ADDENDUM NO. 1

TO: CANYON COUNTY'S INVITATION FOR BIDS CANYON COUNTY FAIR EVENT CENTER FENCE PROJECT

**ADDENDUM NO. 1
QUESTIONS AND CLARIFICATIONS**

Canyon County Fair Event Center Fence Project

Attachment 1

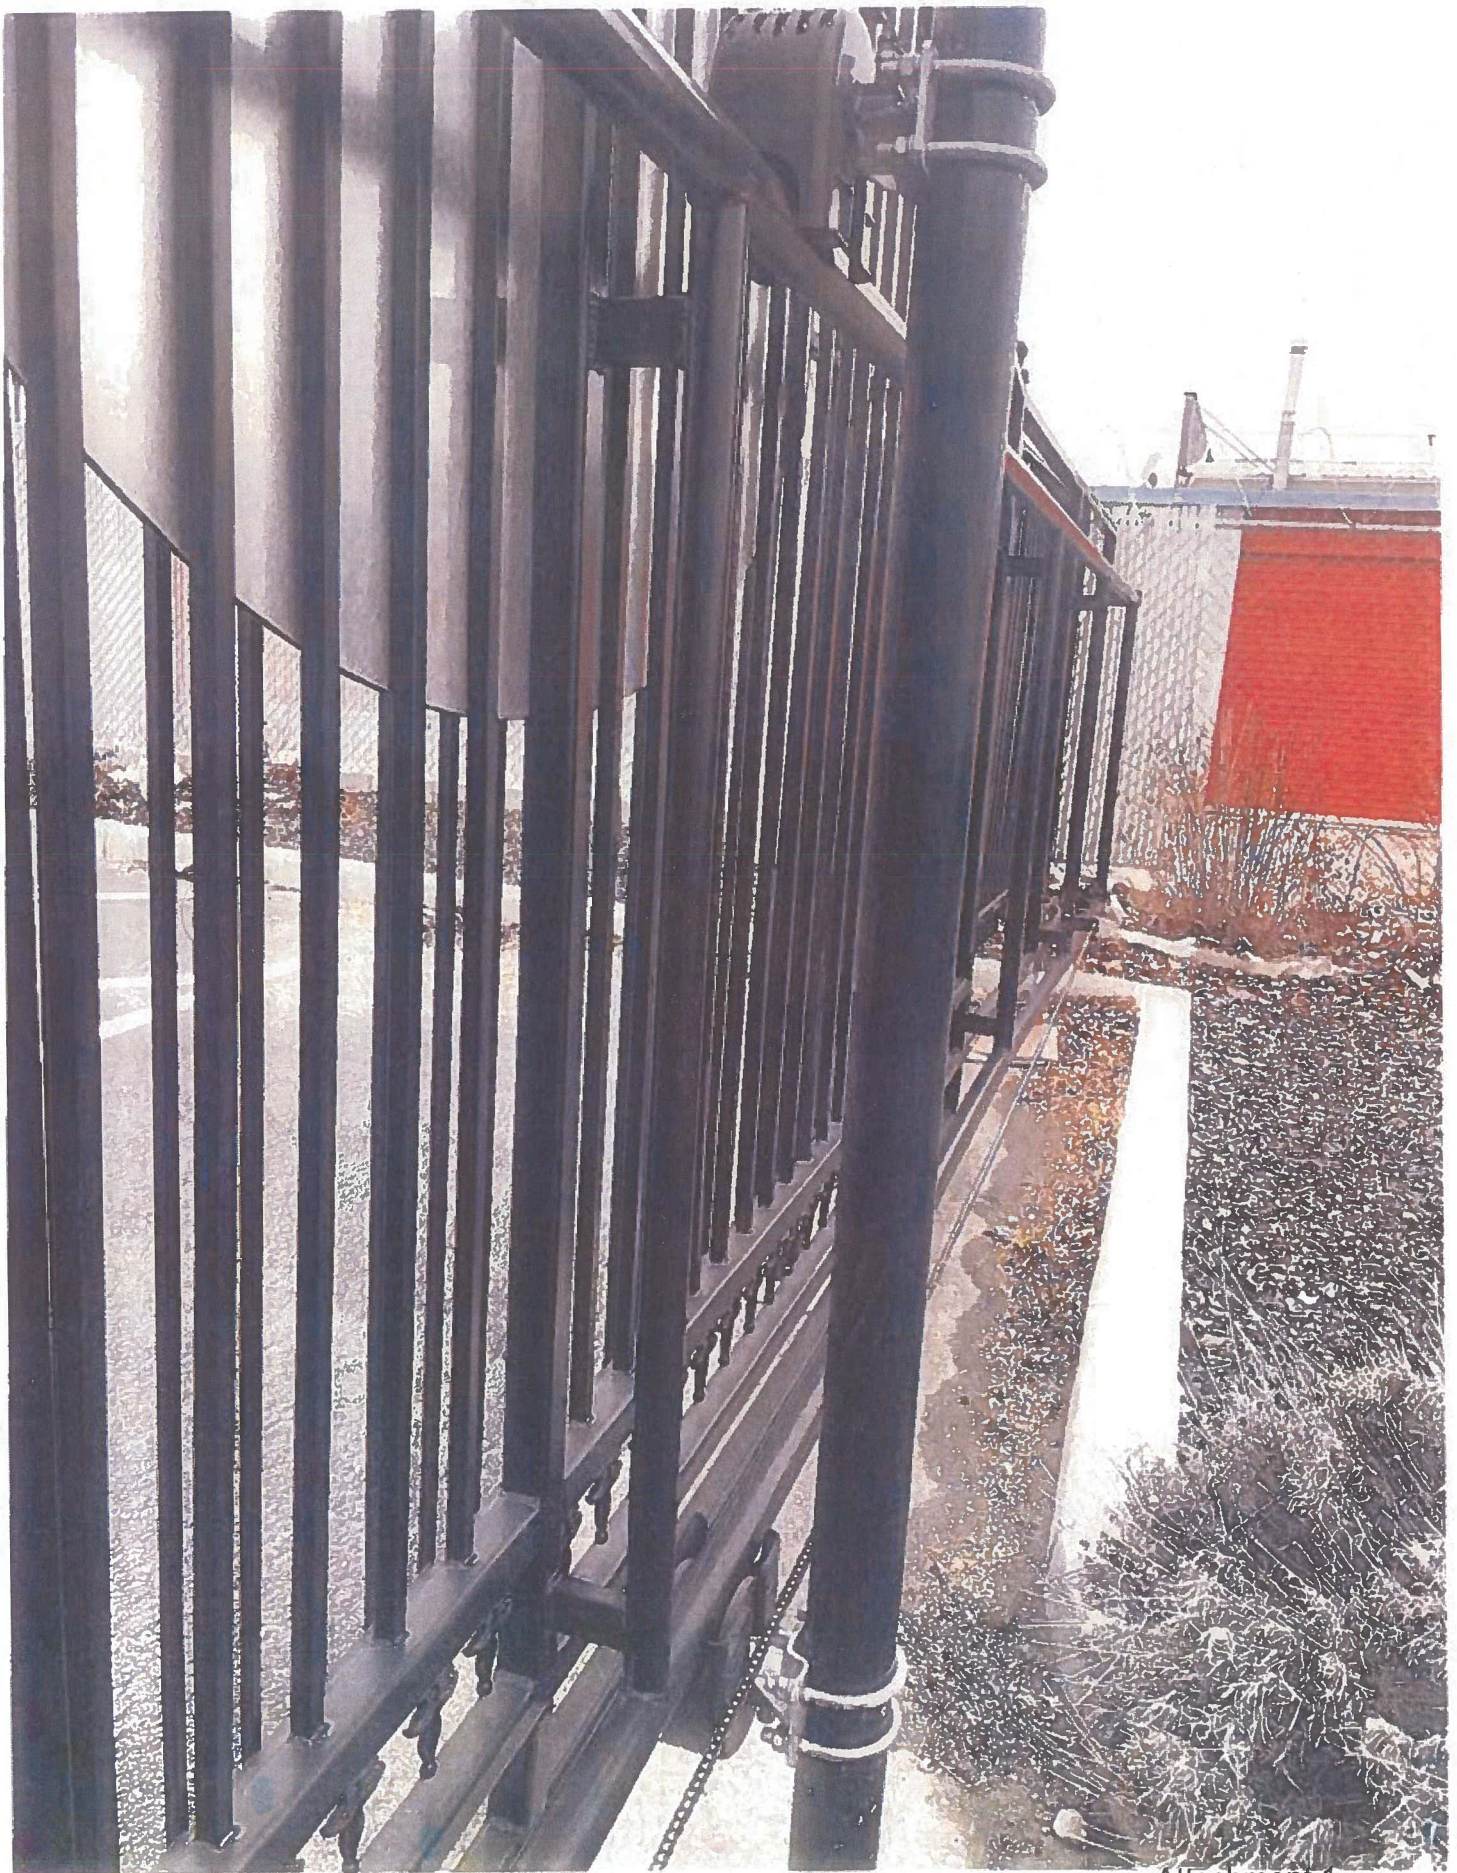
- A.2. Open ground for majority of fence. Core drilling will be necessary for gates on concrete and asphalt.
 - Q.3. Gates- More details are needed to construct the desired gates. Drawings, or photos to ensure conformity.

- A.3. See Attachment No. 1 for promotional material that illustrates a potential design of the slide gates and swing gates. This example is not binding. The selected contractor will be responsible for design and installation of the gates.
